Washington Public Power Supply System

RESPONSE TO THE SECOND ROUND OF
QUESTIONS ON TOPICAL REPORT WPPSS-FTS-129

Figure 19

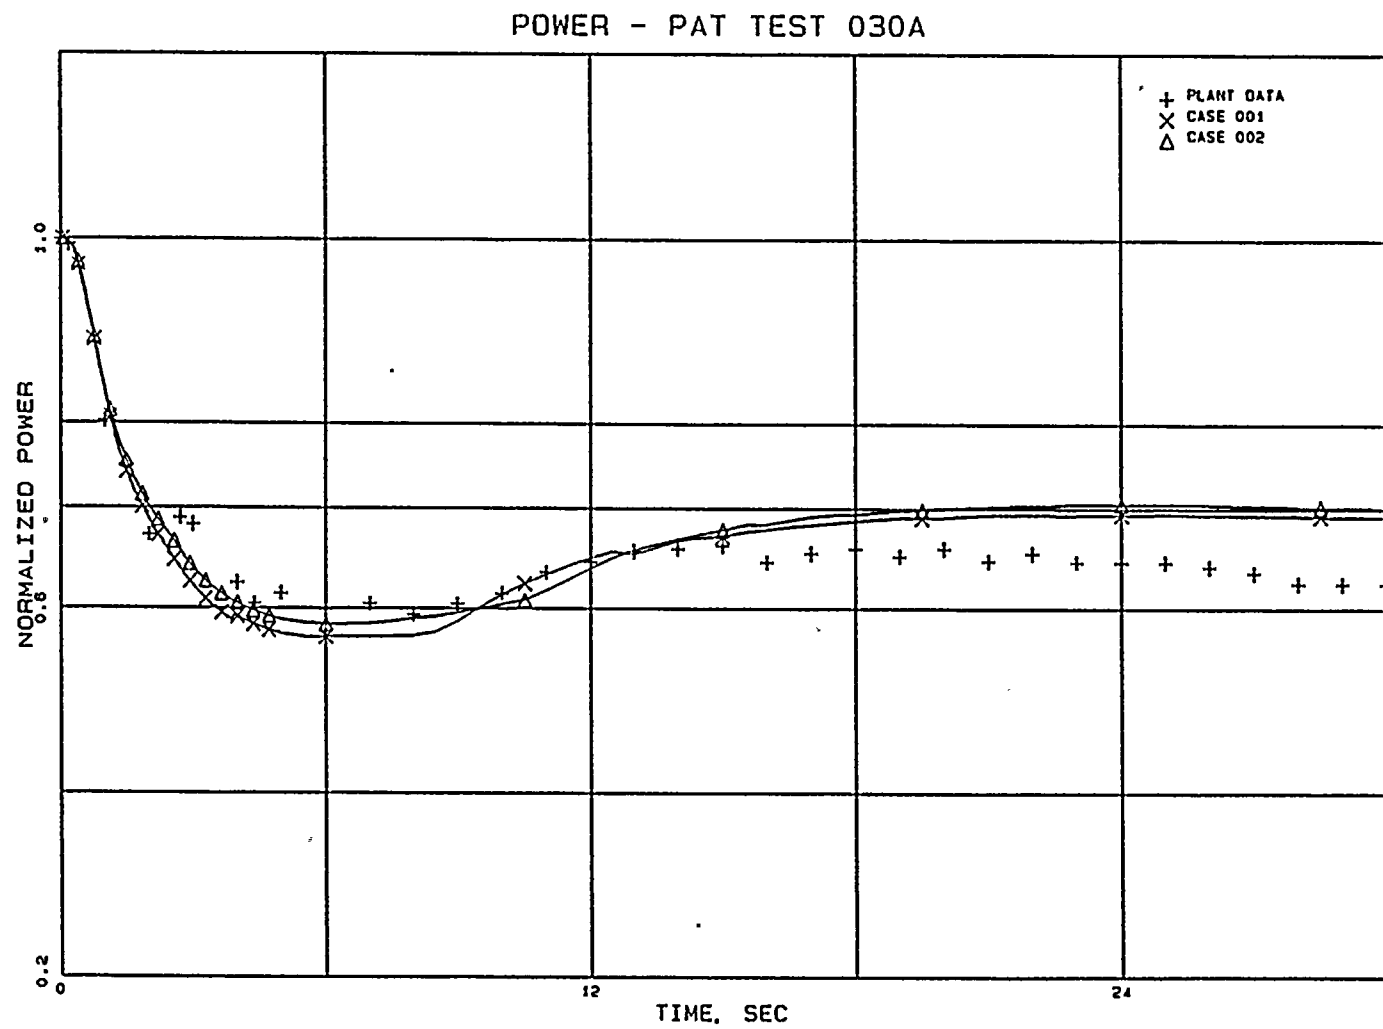
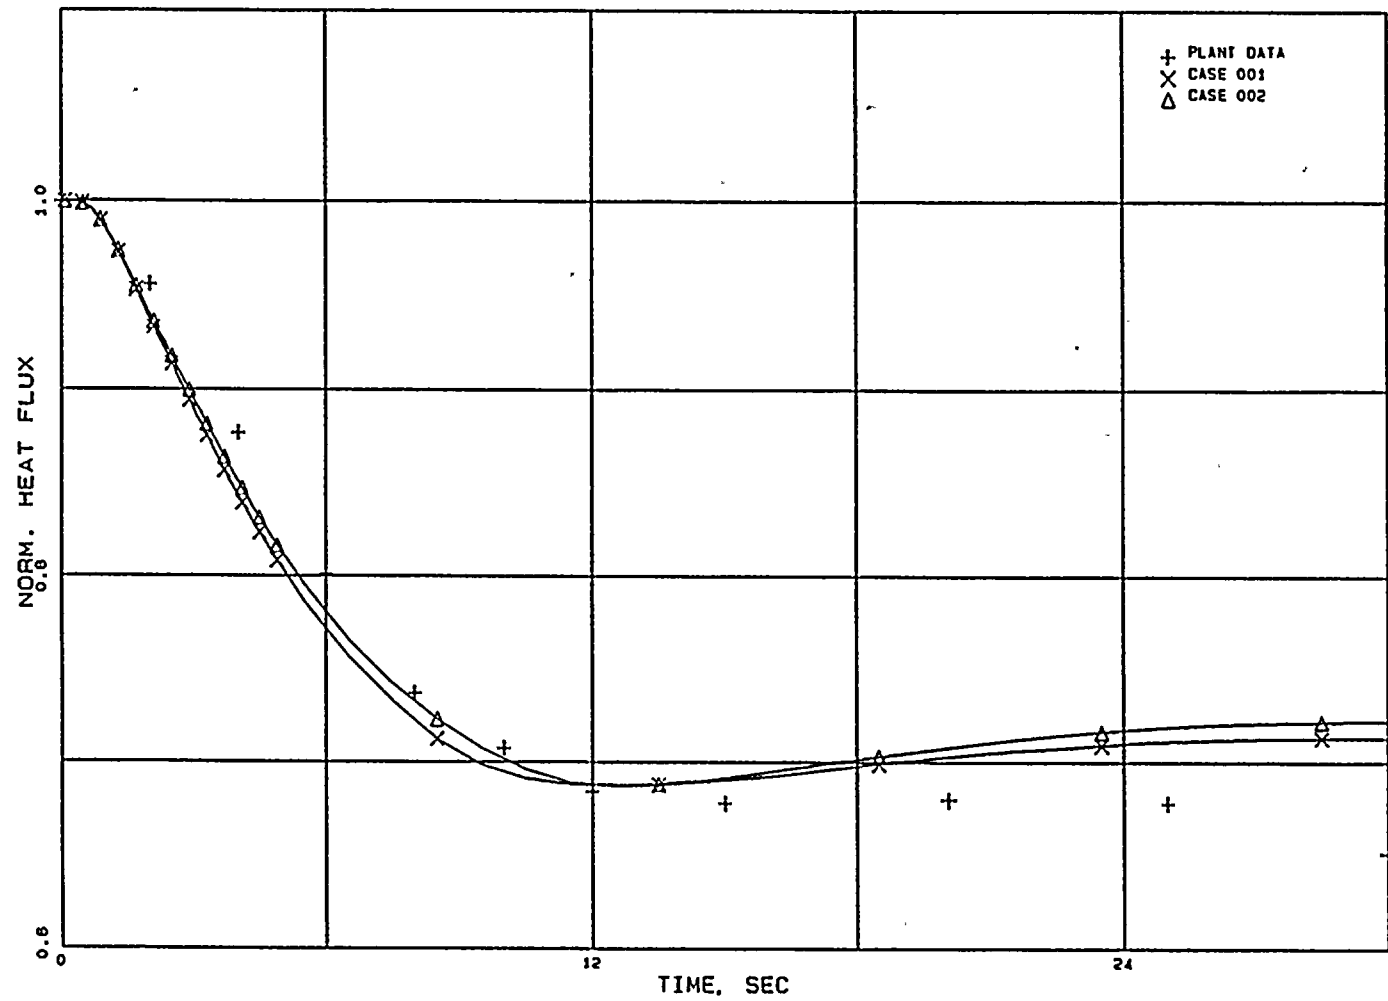
Redo RETRAN simulation for PAT Tests 30A and 027 using the actual plant initial conditions instead of the rated conditions and discuss the impact of the changes. The RETRAN code used should have the correction on recirculation pump flow symmetry. In addition, the results should be compared to the plant data in a non-normalized form.

Figure 19 indicates that the effect of changing the initial conditions is small on the core power calculations. This is also true for the core average heat flux as evidenced in Figure 20.

In summary, using the measured plant data at the initiation of the transient for PAT 30A generally gives a better comparison with the plant data throughout the transient. The effects on key parameters such as power and heat flux are small. The same conclusion is also true for PAT 027 (see Question 1).
